BULLETIN: 25963

Front Wheel Drive Lower Ball Joint Wear

1992-1996
General Motors Minivan

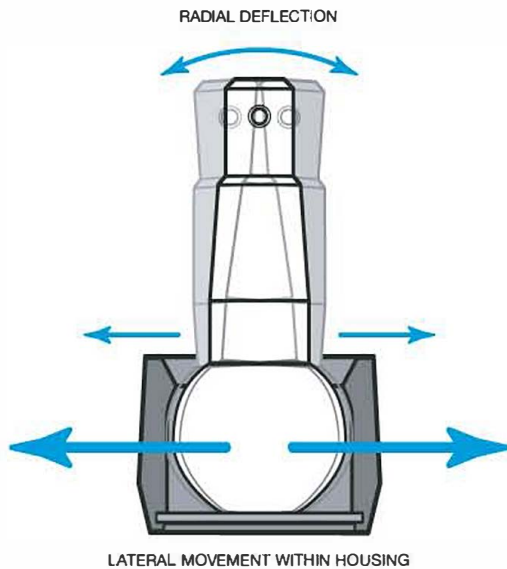
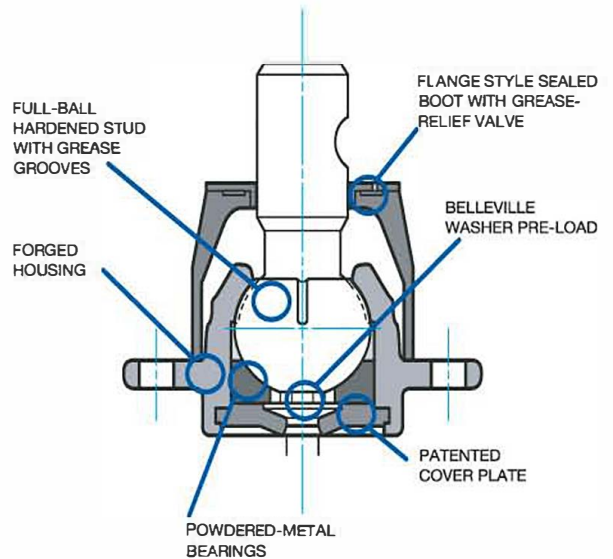
Premature ball joint wear

- Lateral deflection (side to side) loading causes excessive wear in ball joint.

MOOG[®] improved design part number K6429

- Utilizes patented MOOG cover plate design and NASCAR[®]-proven split-bearing technology, which eliminates the excessive radial deflection often experienced with high lateral loads. The ball joint assembly maintains maximum ball-to-bearing contact for greater load-carrying capability.
- Belleville washer pre-load provides lower torque and stud articulation with minimal axial clearance.
- Hardened powdered-metal bearings provide a smooth, durable wear surface that extends service life.
- A flange-style sealed boot equipped with a special grease-relief valve keeps contamination out and provides a serviceable sealed environment.
